**Subject: Geotechnical Consultation  
 Cedar Cove Lot 12  
 Weber County, Utah  
 CG Project No.: 130-001**

At your request, the Christensen Geotechnical has reviewed the geotechnical engineering report “Geotechnical Study, Cedar Cove Lot 12, Weber County, Utah” by Earthtec Testing & Engineering (Earthtec) dated September 19, 2007. The purpose of the review was to assess whether the existing report is adequate for the design and construction of a proposed single family residence on the subject lot. This letter was prepared this to present our opinion regarding the review of this report.

Plate  
**3**

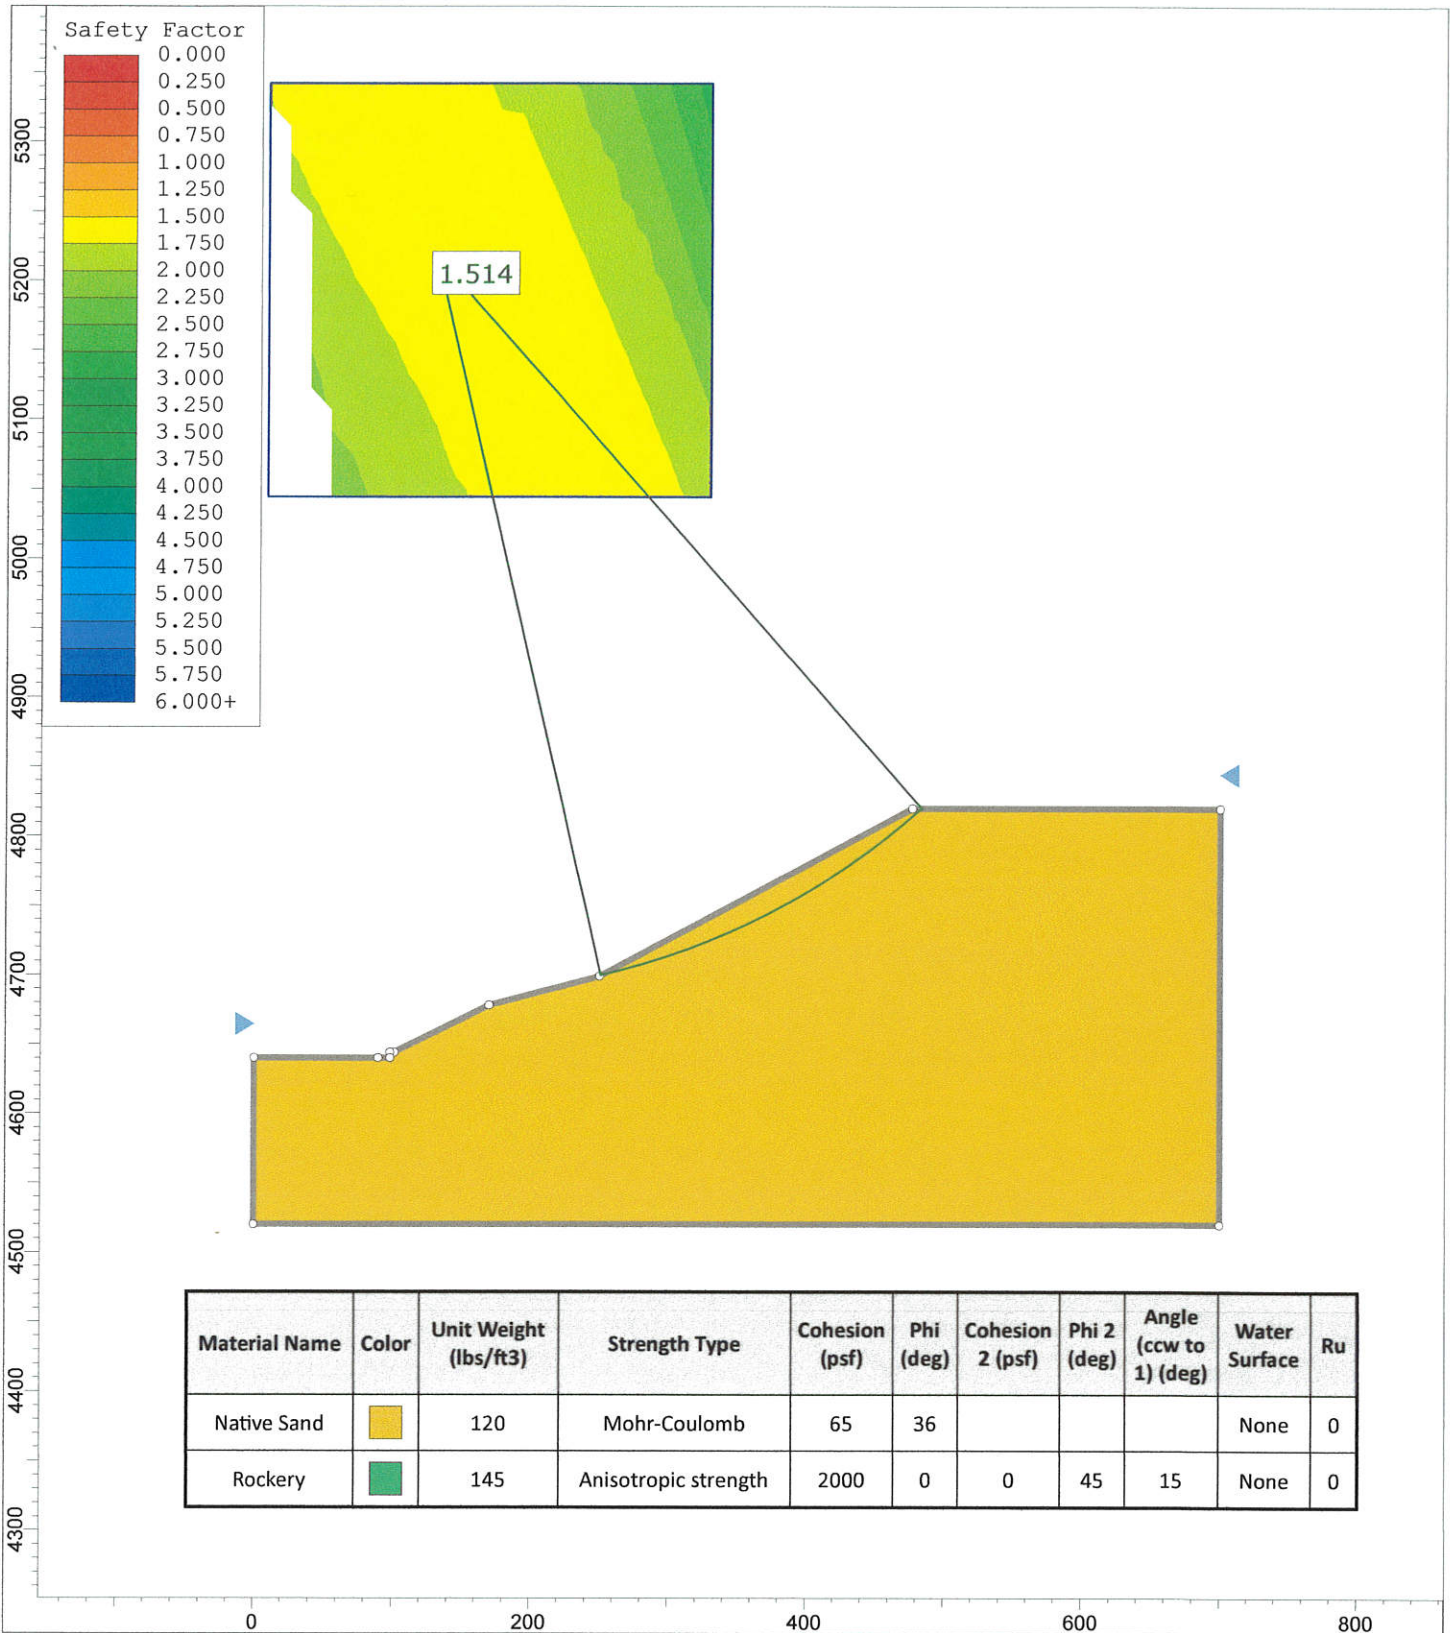
Based on conversations with you, we understand a retaining wall on the order of 4 feet in height will be constructed at the toe of the existing slope on the lot. No other significant changes to the slope are planned. The global stability of the slope was assessed with the Slide computer program by Rocscience and the bishops simplified method of slices. The soil strength used in our analyses was based on a direct shear test performed on a soil sample collected from the slope. The profile used was based on the Earthtec profile presented in their geotechnical report. The slope was assessed under static and pseudo static conditions. The pseudo static condition is used to assess stability during a seismic event. As indicated above, the peak ground acceleration at the site is estimated to be 0.51g. As is common practice, half of the PGA was used in our analysis. Factors of safety of 1.5 and 1.0 are typically considered acceptable for residential construction. The results of our analyses indicate a static factor of safety greater than 1.5. The pseudo static stability of the slope was assessed to be less than 1.0. Due to the low factor of safety, a deformation analysis was performed using the Bray and Tavasrou 2007 method. This analysis estimated 9 inches of slope deformation during a large seismic event. Given the estimated 9 inches of deformation, it is our opinion that the 20 foot setback from the toe of the slope as recommended in the Earthtec geotechnical report is adequate and should be followed. The results of our slope stability assessment may be found on Plates 3 and 4.
